Application No. 6

Land Use Plan Map and Traffic Circulation Subelement Amendment

Roadway Access Options for Construction of Florida Power and Light (FPL) Turkey Point Units 6 & 7

Appendix A: Applicant's Figure 3.1 - Roadway and Associated Facilities Required in Connection with Expansion of Nuclear Power Plant

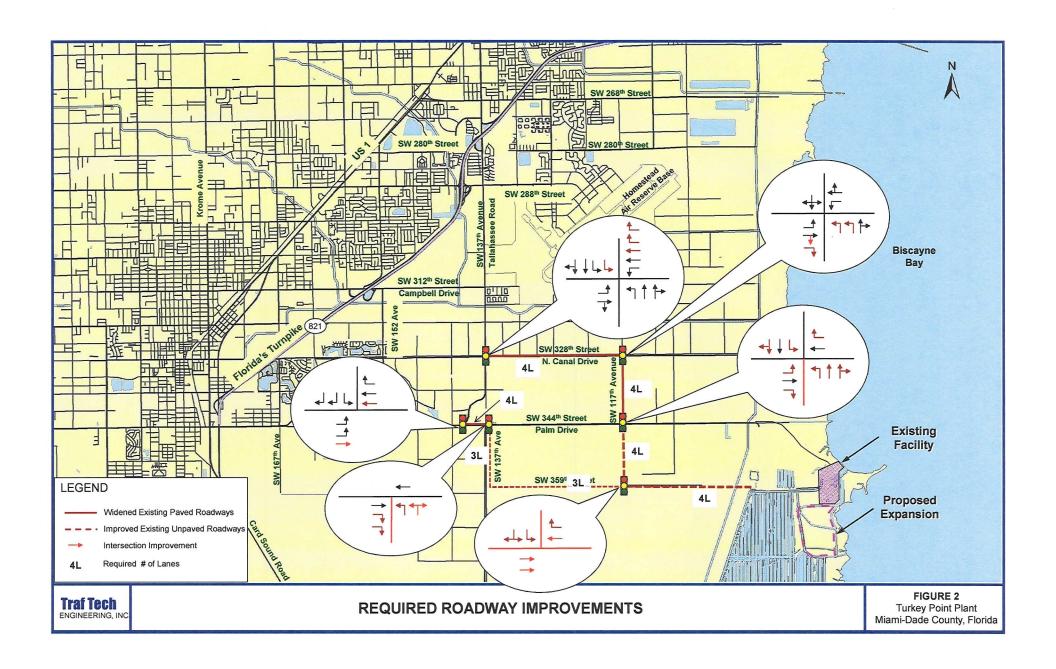
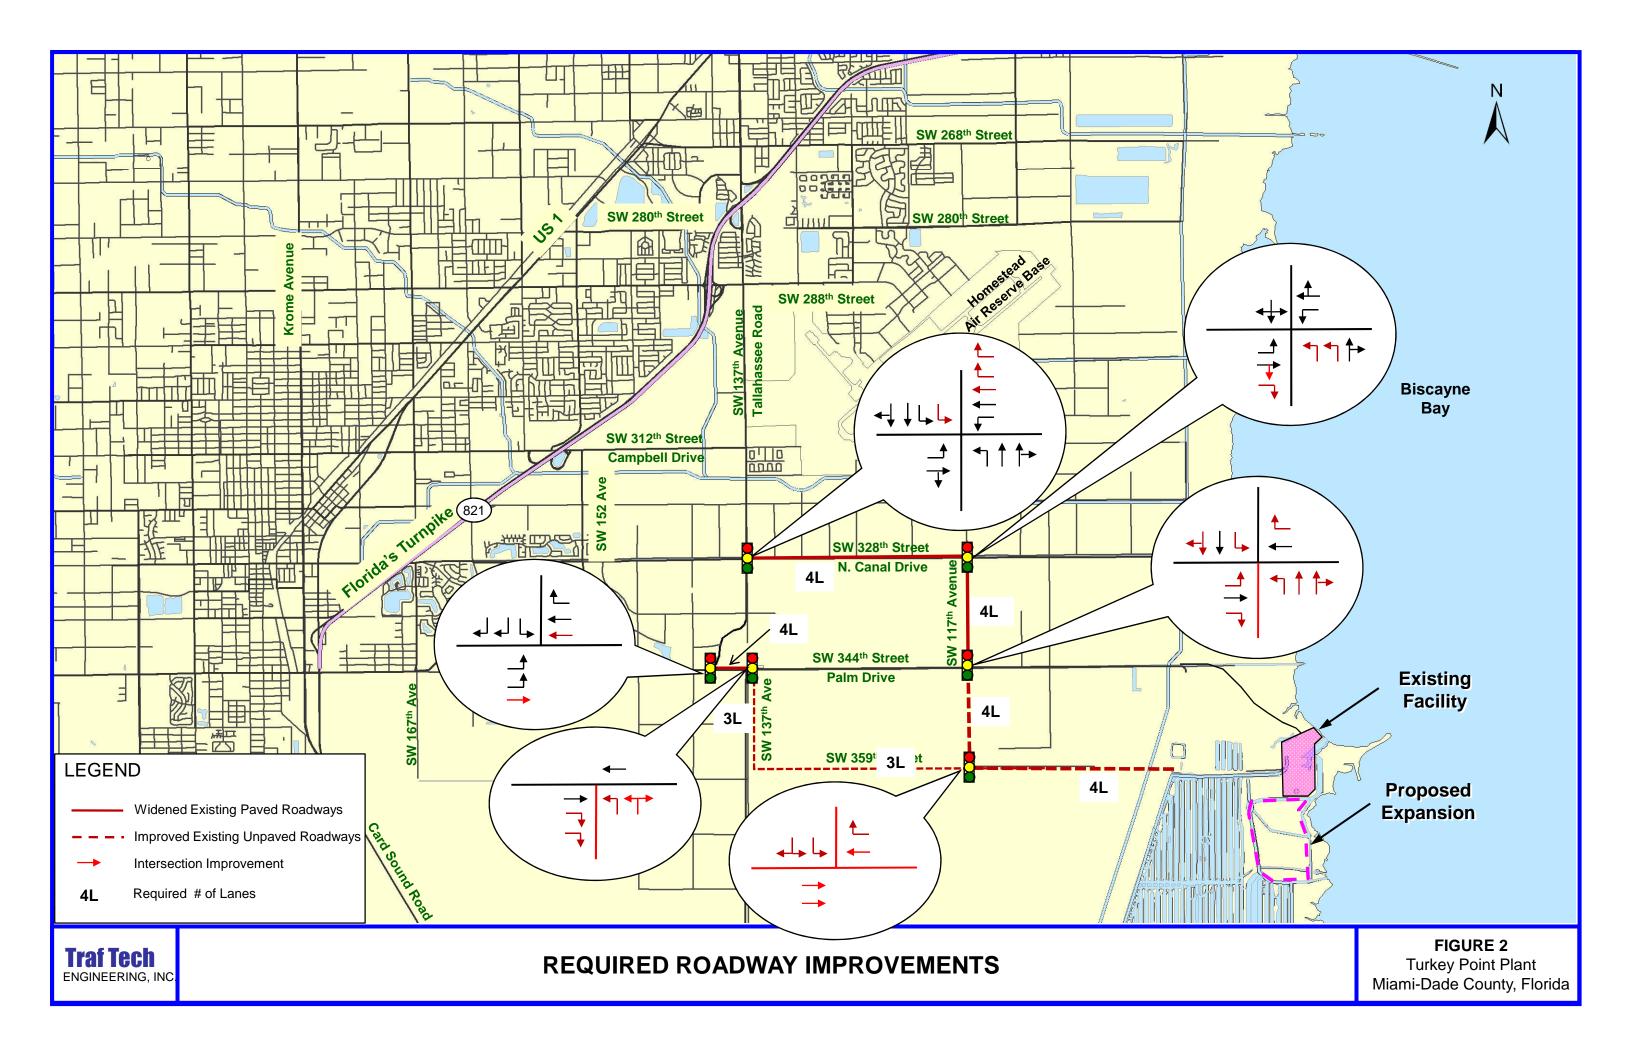
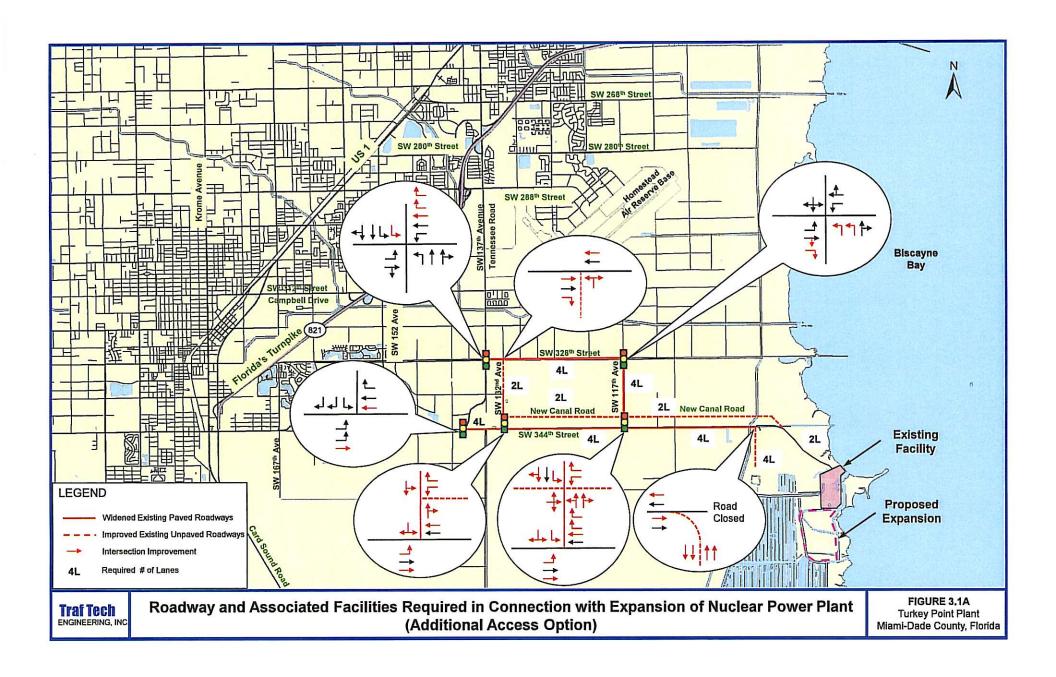
Amendment 3) Include a new Figure 3.1 titled "Roadway and Associated Facilities Required in Connection with Expansion of Nuclear Power Plant," into the CDMP Traffic Circulation Subelement maps series.

As transmitted by the Board of County Commissioners to the Department of Community Affairs (DCA), Figure 3.1 shows both the SW 359 Street Access Option and the Canal Roadway Access Option. Both figures are attached as Appendix A. Based on planning and environmental considerations as summarized below, the Department recommends that the Canal Roadway Access Option be adopted into Figure 3.1 – Temporary Roadways and Roadway Improvements in Connection with the Construction of Turkey Point Units 6 & 7. A revised Figure 3.1 showing the Canal Roadway Access Option is attached as Appendix B.

- 1. In the Initial Recommendations Report published on August 25, 2009, the Staff recommended: DENY AND TRANSMIT the proposed amendment. This original request, proposed the SW 359 Street Access Option, which includes: the widening from 2 to 4 lanes of following existing roadways: SW 328 Street between SW 137 Avenue and SW 117 Avenue, SW 117 Avenue between SW 328 Street and SW 344 Street, and SW 344 Street between SW 137 Avenue East and SW 137 Avenue West. And the construction of three new roadways: SW 137 Avenue between SW 344 Street and SW 359 Street as a 3-lane facility, SW 117 Avenue between SW 344 Street and SW 359 Street as a 4-lane facility, and SW 359 between SW 137 Avenue and the Turkey Point Plant site as a 4-lane facility. See Appendix A.

- 2. In the "Supplement to the Initial Recommendations Report", dated October 28, 2009, the Department amended its recommendation to TRANSMIT due to additional information submitted by FPL, the desire to continue working towards a solution that would be mutually acceptable for the proposed project, and the inclusion of a second roadway alignment (Option 2), herein referred to as the "Canal Roadway Access Option". The Department's preferred Canal Roadway Access Option, includes in addition to the proposed widening (from 2 to 4 lanes) of the existing roadways (SW 328 Street between SW 137 and SW 117 Avenues and SW 117 Avenue between SW 328 and SW 344 Streets), the widening (from 2 to 4 Lanes) of SW 344 Street between SW 137 Avenue and the entrance to the Turkey Point Power Plant site; and the construction of two new 2-lane roadways, SW 132 Avenue between SW 328 and SW 344 Streets and theoretical SW 342 Street (Canal Road) along the north side of the Florida City Canal. See Appendix A.

- 4. **Traffic Assessment of Options** Traffic assessments made by FPL consultants have confirmed that both the Canal Roadway Access Option and SW 359 Street Access Option as transmitted by the County to DCA will accommodate the anticipated traffic flow associated with Construction of Turkey Point Units 6 and 7.

- 5. Loss of Wetlands A Wetland Functional Assessment was submitted by FPL showing the direct and indirect impacts to both the Canal Roadway Access Option and the SW 359 Street Access Option. This assessment indicates that the Canal Roadway Access Option

Staff recommends that this amendment be modified. The title of Figure 3.1 should be renamed to "Temporary Roadways and Roadway Improvements in Connection with the Construction of Turkey Point Units 6 and 7". This new title shows that the roadway improvements are temporary and that their approval is tied to the construction of Turkey Point Units 6 and 7. The previous title of Figure 3.1 did not appropriately identify the roadways and roadway improvements as "temporary", and did not limit the need for the roadways to construction activities of Unit 6 and 7.

Appendix B: Proposed Figure 3.1 - Temporary Roadways and Roadway Improvement in Connection with the Construction of Turkey Point Units 6 and 7

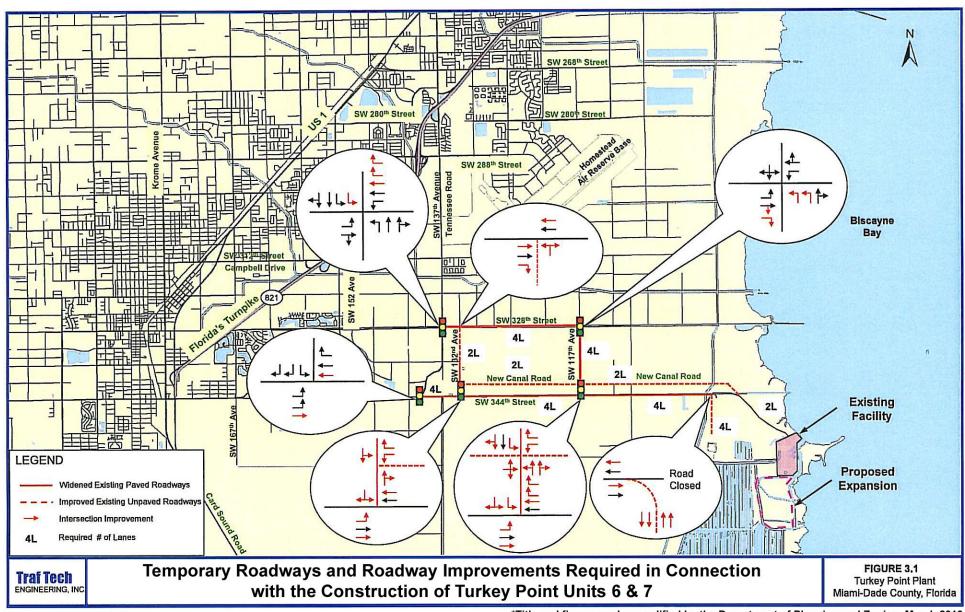
In summary, a Wetlands Functional Assessment Summary submitted by FLP shows that the Canal roadway Access Option has fewer direct wetland impacts than does the SW 359 Street Access Option. DERM, DEP and SFWMD have expressed concerns regarding a variety of issues associated with the SW 359 Street Access Option. These include: further compartmentalization of the high quality wetlands habitat located south of SW 344th street, increased potential for road kill impacts on rare, threatened and endangered species, increased access for unauthorized activities in publically owned land including County owned Environmentally Endangered Lands along SW 359th Street, and consistency with regional restoration goals associated with CERP, and long term land use planning implications associated with placement of the roadway improvement among others. Additionally, the Canal roadway Access Option has less potential environmental impacts and impacts to CERP projects making the Canal roadway Access Option more consistent with the CDMP goals, objectives and policies. Therefore the Department contends that co-locating additional temporary roadway access along SW 344th street represents the best balance for providing sufficient construction site access, while minimizing the potential negative affects noted above.

FPL has demonstrated that additional right-of-way must be purchased or leased to accommodate the two lane roadway to the north of the canal as outlined in the Canal roadway Access Option; however, the Department believes that FPL can utilize their condemnation power to acquire the necessary right-of-way in a manner that will not jeopardize their construction schedule. The County is willing to work with the applicant to ensure that the Canal Roadway Access Option is implemented. Furthermore, the Department recommends that should modification to the Canal Roadway Access Option be necessary after adoption of this amendment, due to limited road right-of-way or other unforeseen issues, the County will file any necessary amendments to Figure 3.1 to ensure consistency of the final temporary roadway and roadway improvements with the CDMP.

- 2) **Modify** the title of Figure 3.1 from Roadway and Associated Facilities Required in Connection with Expansion of Nuclear Power Plant, to Temporary Roadways and Roadway Improvements in Connection with the Construction of Turkey Point Units 6 and 7;
- 3) **Adopt** Figure 3.1 into the CDMP Traffic Circulation map series showing the Canal Roadway Access Option improvements as noted in Appendix B;
- 4) **Modify** temporary roadway text to be added on page II-17 of the CDMP Traffic Circulation Subelement as proposed by applicant; and,
- 5) Include any covenant adopted by the Board of County Commissioners regarding this application into the CDMP Land Use Element table "Restrictions Accepted by Board of County Commissioners in Association with Land Use Plan Amendments"

*Title and figure number modified by the Department of Planning and Zoning, March 2010
